GREAT LAKES INDIAN FISH AND WILDLIFE COMMISSION

August 11, 2015

Re: Comments on PolyMet mine site contaminant northward flowpath and groundwater model calibration.

Large Figure 30
PREDICTED GROUNDWATER LEVELS
WITHIN THE BEDROCK -
LONG-TERM CLOSURE CONDITIONS
NorthMet Project
Poly Met Mining, Inc.

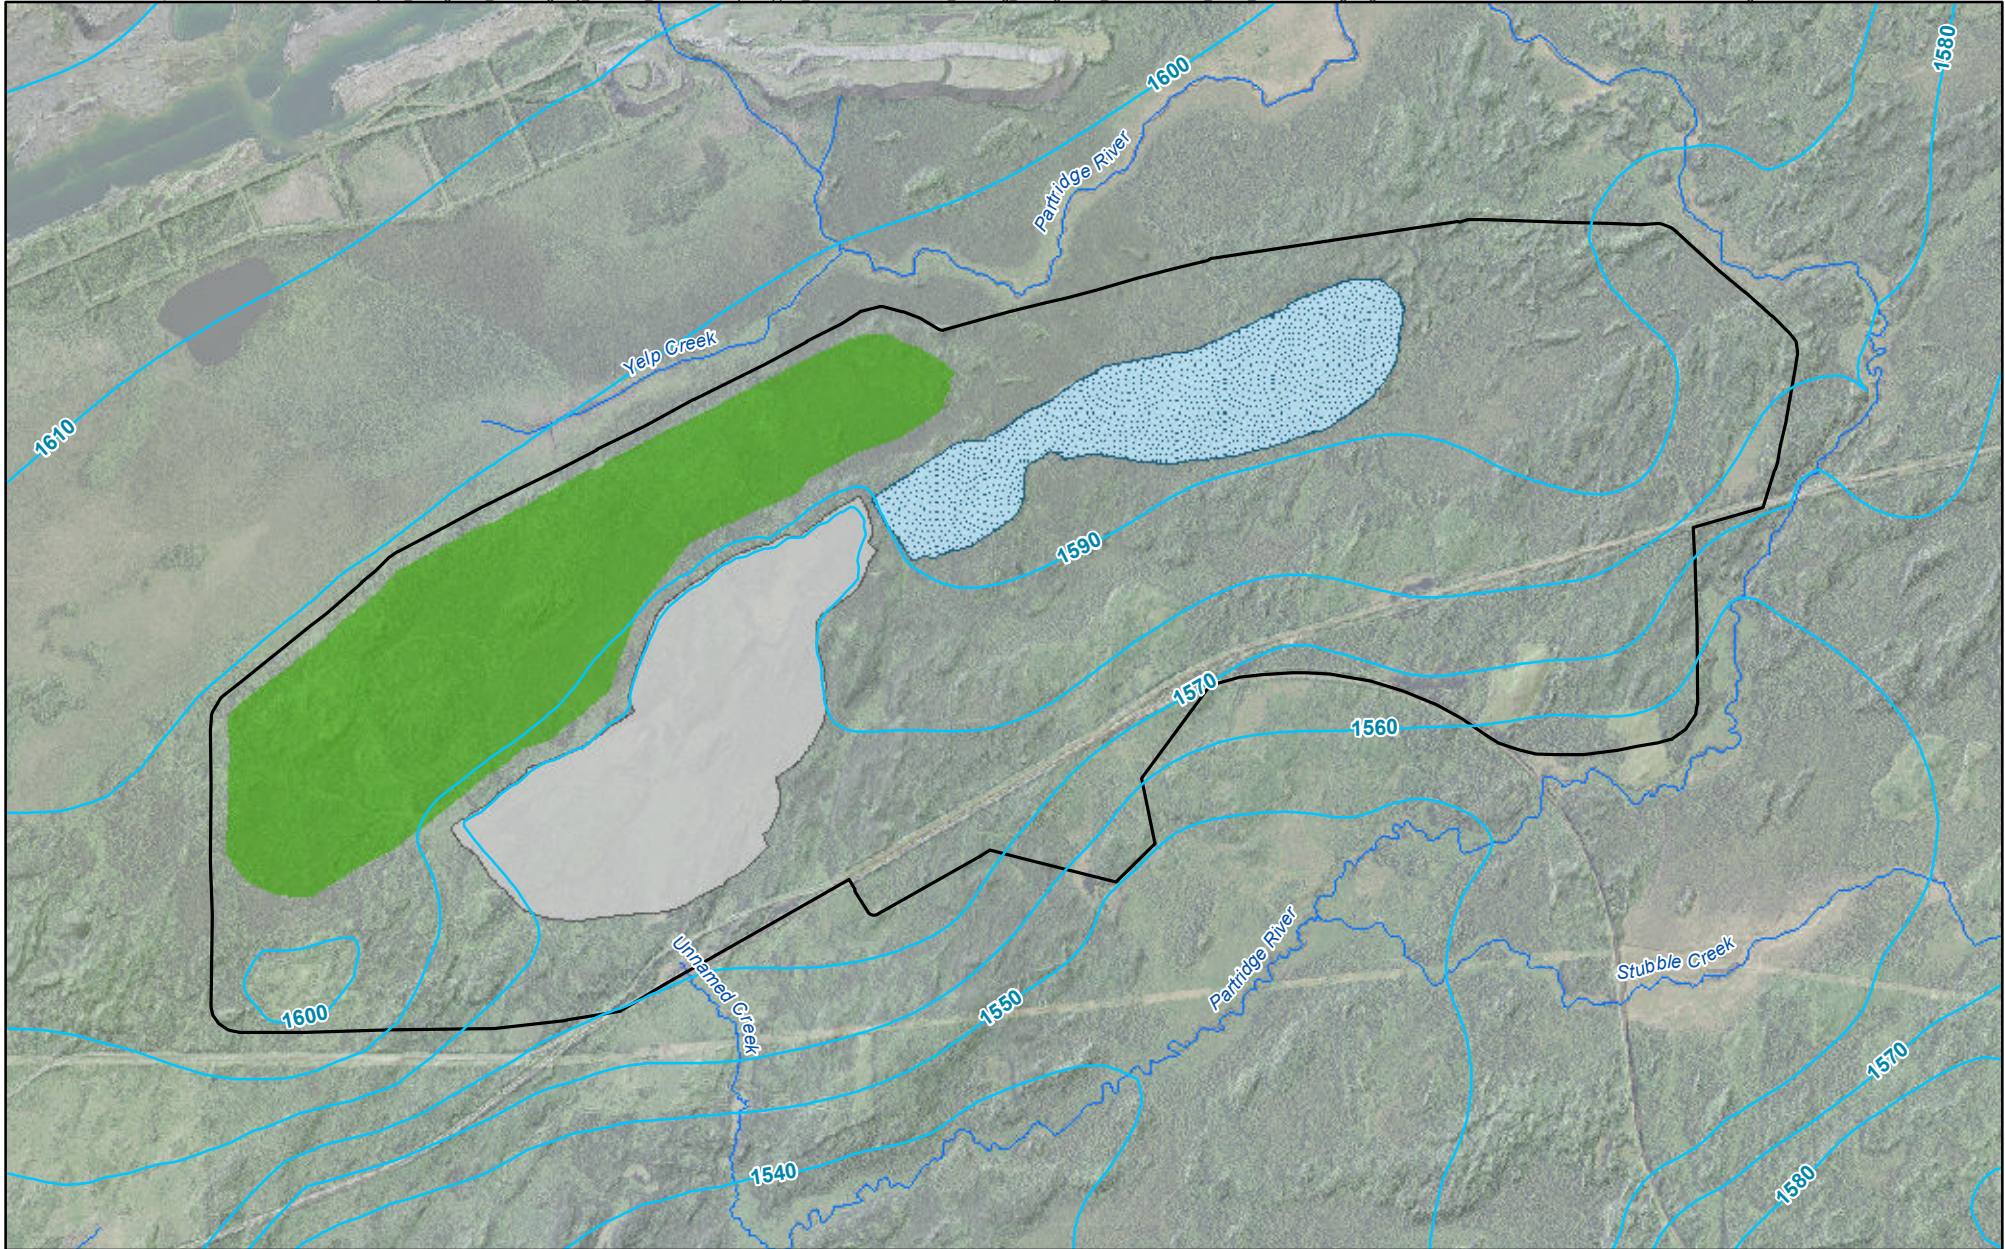
Polymet predicted groundwater levels in the bedrock under long-term closure conditions using the MODFLOW model run referenced above. For example, the attached Large Figure 30 of Attachment B of the Water Modeling Data Package Vol_1-Mine_Site_v13_DEC2014 shows the bedrock water level contours predicted by that model run.

Those predicted contours were used in the Water Modeling Data Package to define flow paths (Large Figure 29 of the Water Modeling Data Package Vol_1-Mine_Site_v13_DEC2014). As stated on page 75 of the Water Modeling Data Package v13 (.pdf page 82):

PREDICTED GROUNDWATER LEVELS
WITHIN THE BEDROCK -
LONG-TERM CLOSURE CONDITIONS
FOR NORTHMET
AND NORTHSORE PROJECTS

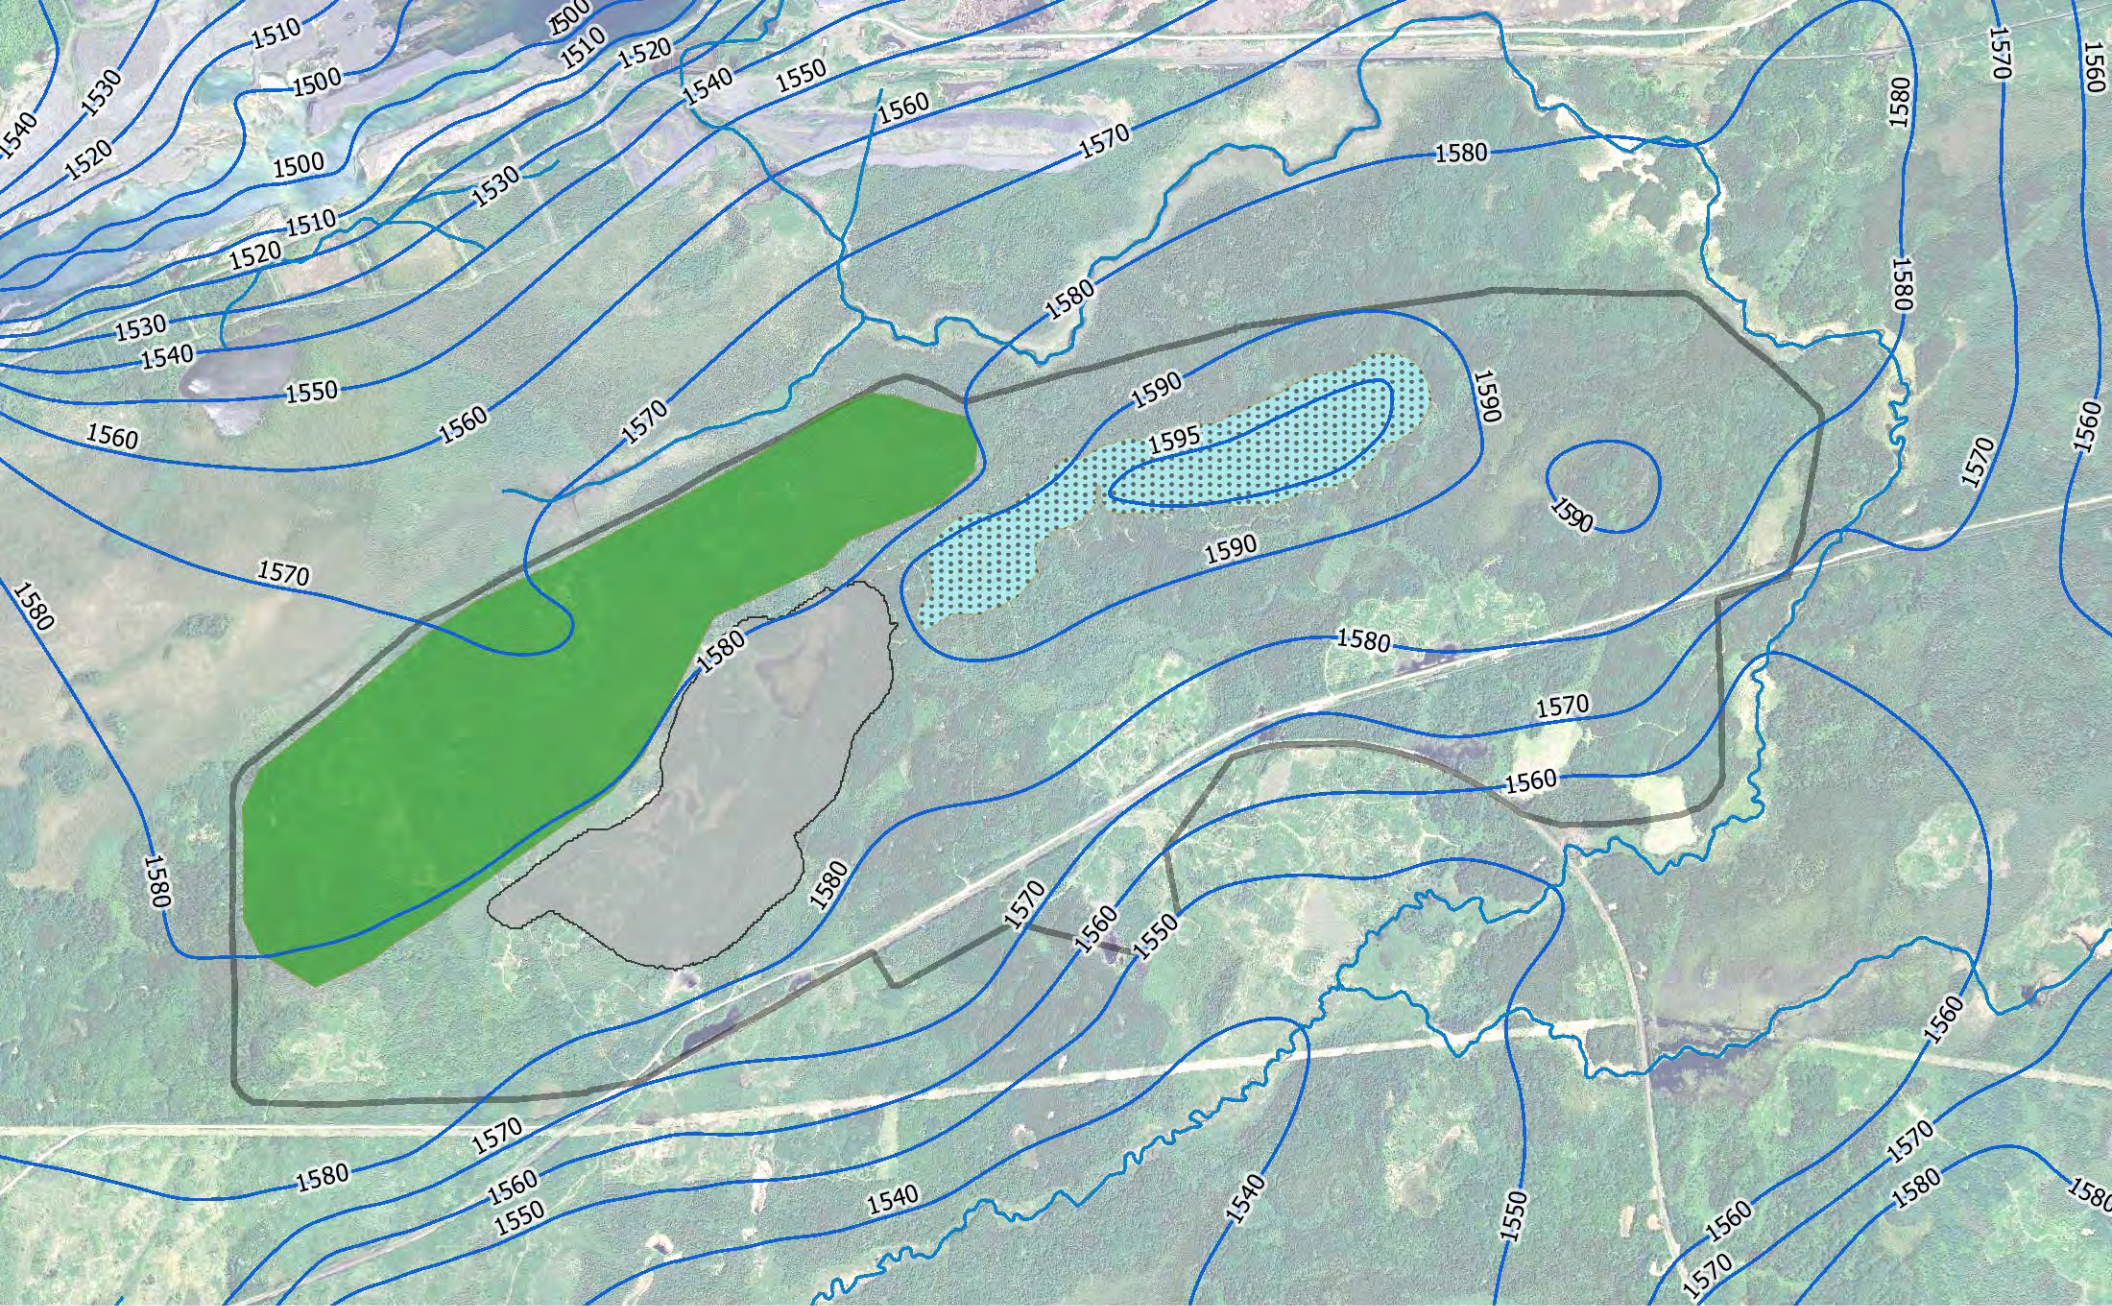
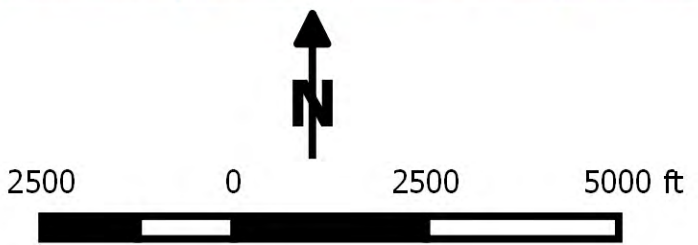
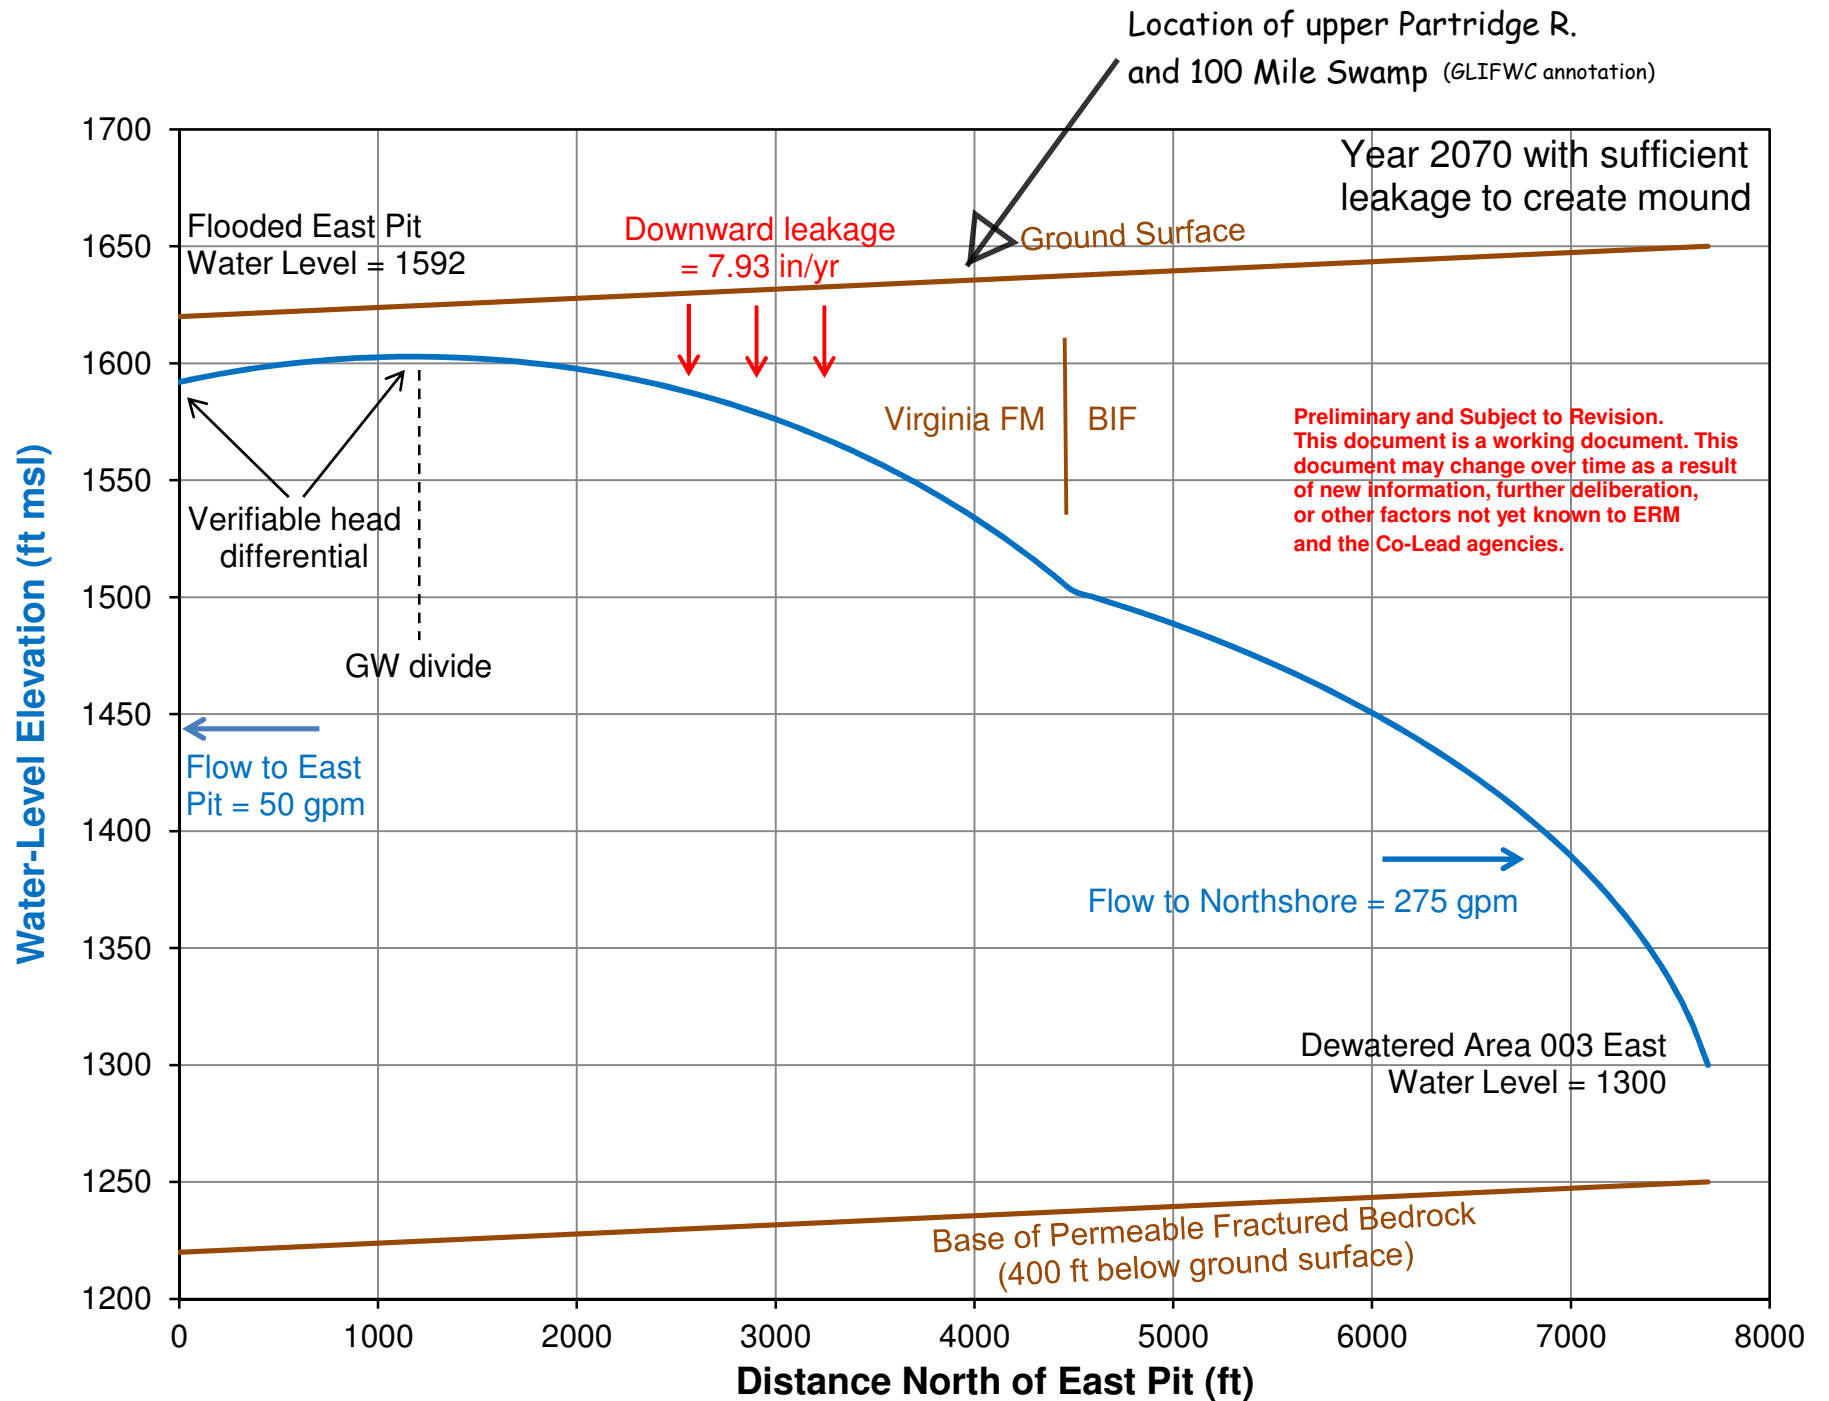
Using the same model "Steady_State_west_pit_filling_Sept2014_1585ft_ec1595ft.gvw" except that water levels in the Peter-Mitchel taconite pits were set at their correct long term level of 1500 feet, we find that the model predicts different groundwater contours in the bedrock (figure attached). Neither "downward leakage" nor any other parameters in the model were modified. The contours predicted by the model when the P-M pits are at their long-term closure level of 1500 ft, indicate that there are bedrock flow paths to the north from the Polymet pits. At the time of Polymet closure, the P-M pits are expected to be at an elevation of approximately 1300 ft, amplifying the effect on the aquifer.

Polymet - Leakage conditions for mound at year 2070

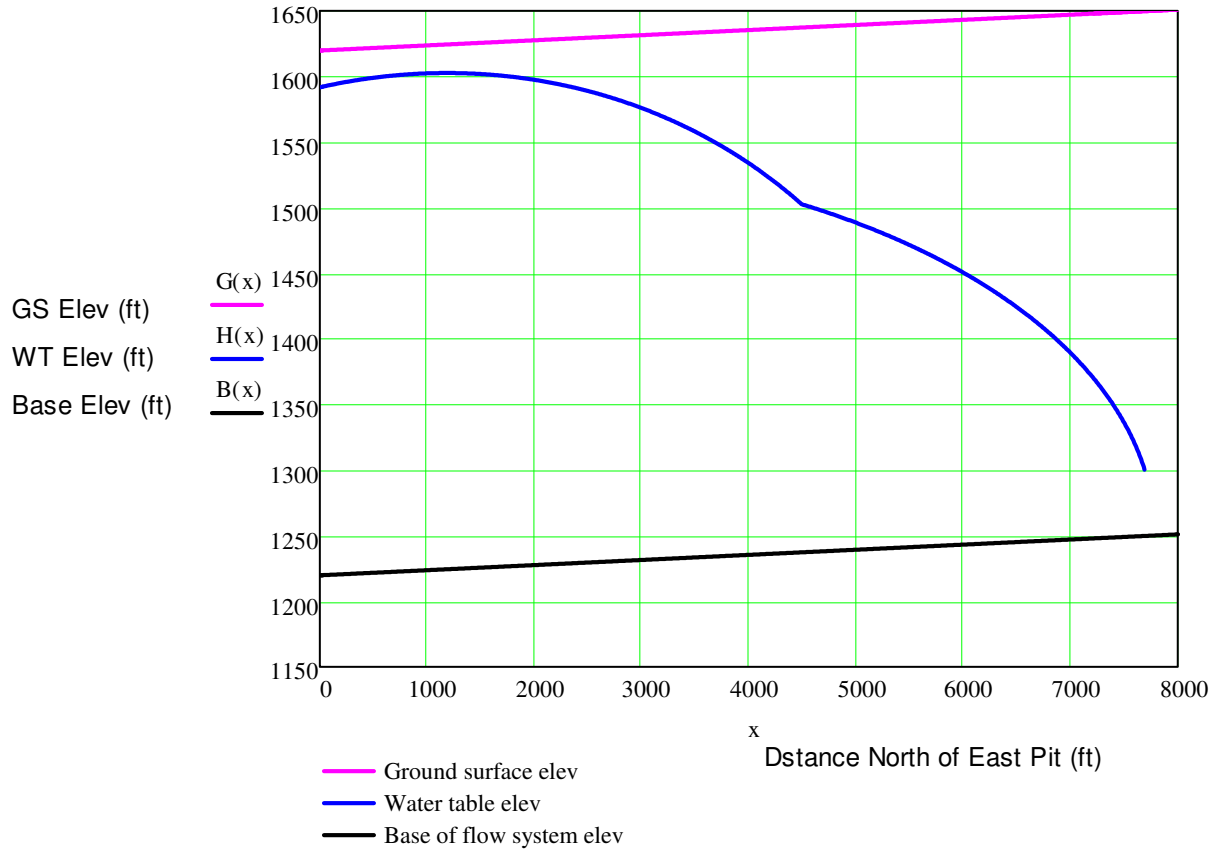
Iterate on QQ_0 and/or WW until the head at $x = LL$ is 1300 ft; that is, $H(L) = 1300$

This solution is for 1-D horizontal flow and accounts for:
Variable saturated thickness
Uniform downward leakage
Sloping aquifer base
